ADDENDUM NO. 2

Project Name: Sector 3 Beach and Dune Restoration

Bid Number: 2021012

This addendum is being released to provide answers to questions received and provide the updated Technical Drawings for the project.

DRAWING NO. **XS-1**
 SHEET 32 OF 44

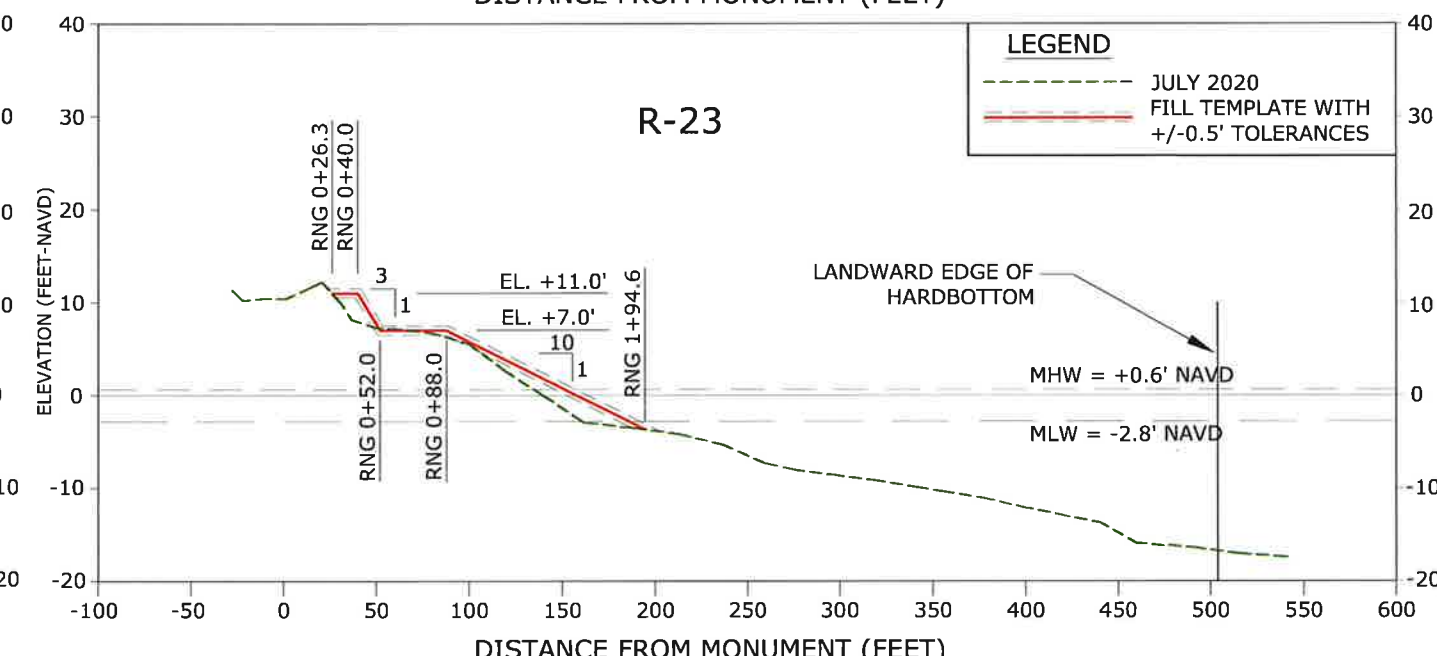
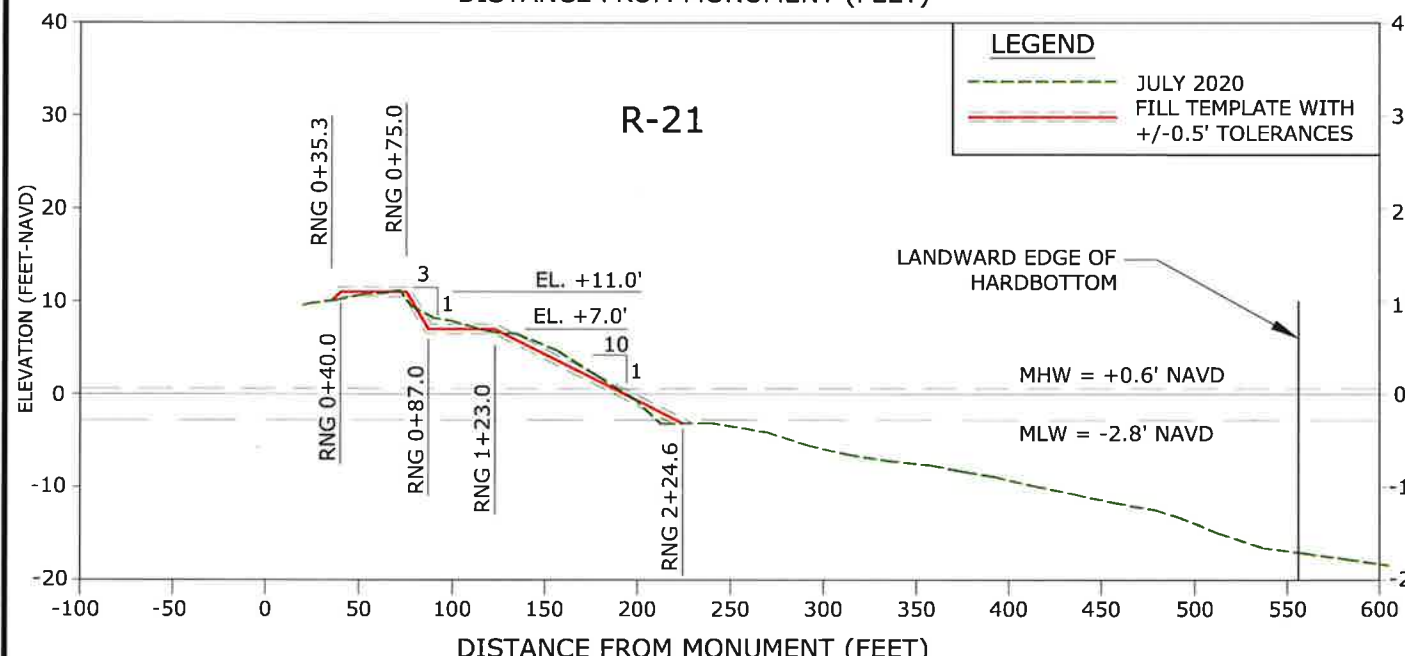
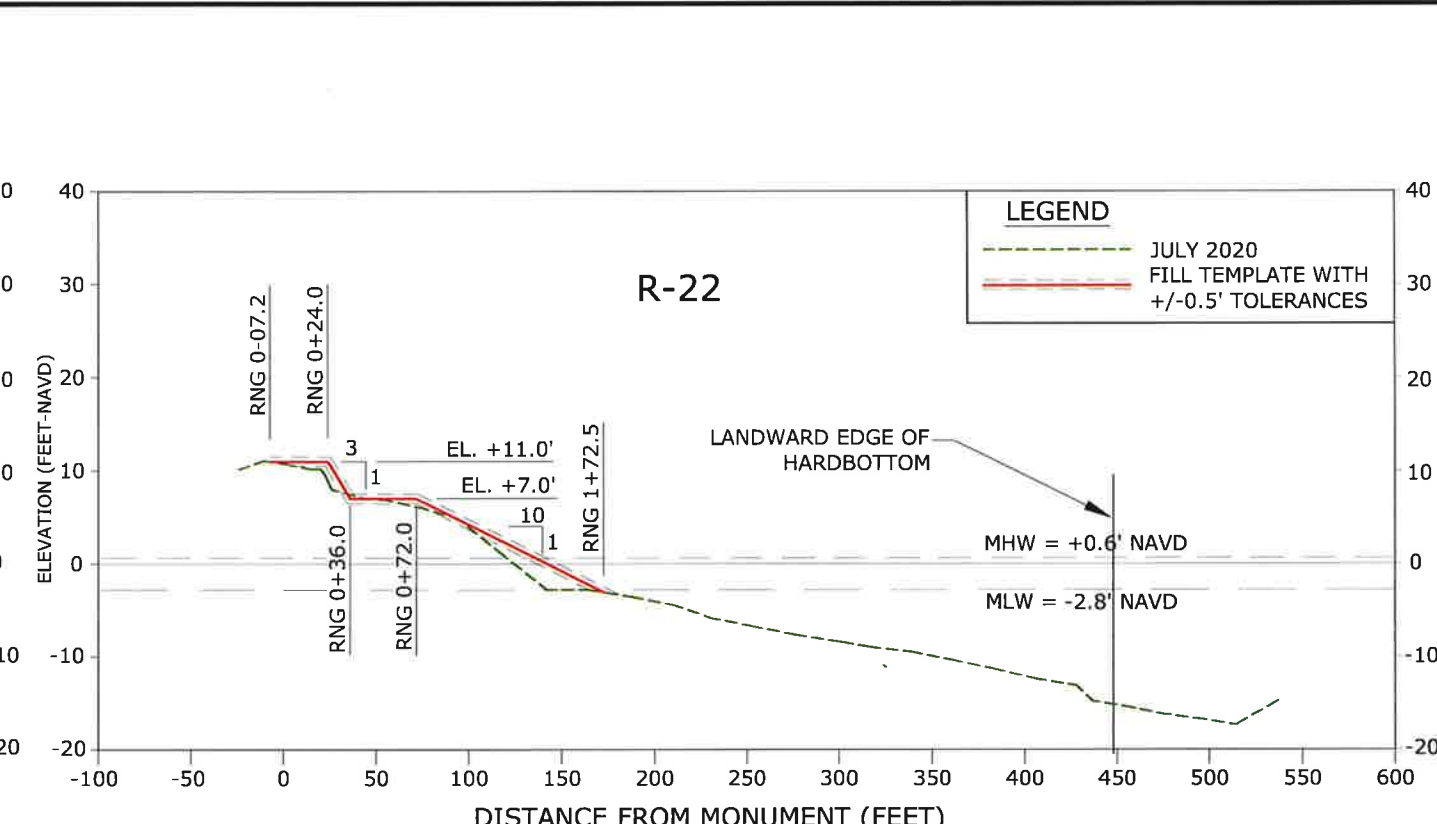
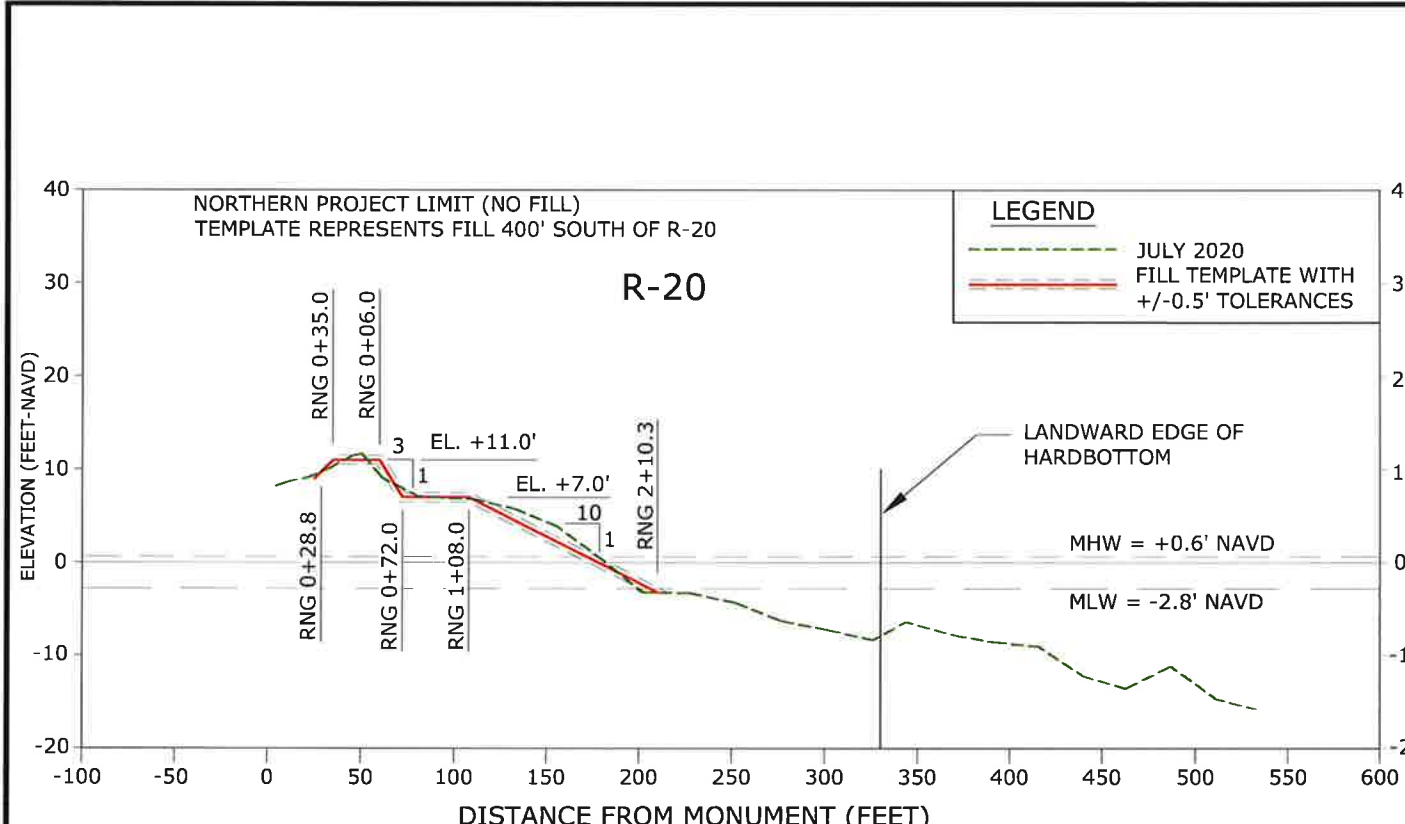
- 4. Q.** The Plan Sheets provided for this project appear to be the same as the previous Sector 3 Beach Fill Project. Please provide updated Plan Sheets, indicating the revised fill extents and design.

A. Revised sheets included as part of this addendum.
- 5. Q.** Based on internal takeoffs of the beach fill template provided, we note that the advertised quantity is not sufficient to reach R-40, falling several thousand feet short. Please clarify.

- A. As identified in the Technical Specifications, construction for this bid is to take place between FDEP R Monuments R-20 and R-40. The fill templates for this section have been updated to reflect the inclusion of the summer 2020 surveys, and as such, fill volumes and dune plantings have been adjusted to reflect this information.**
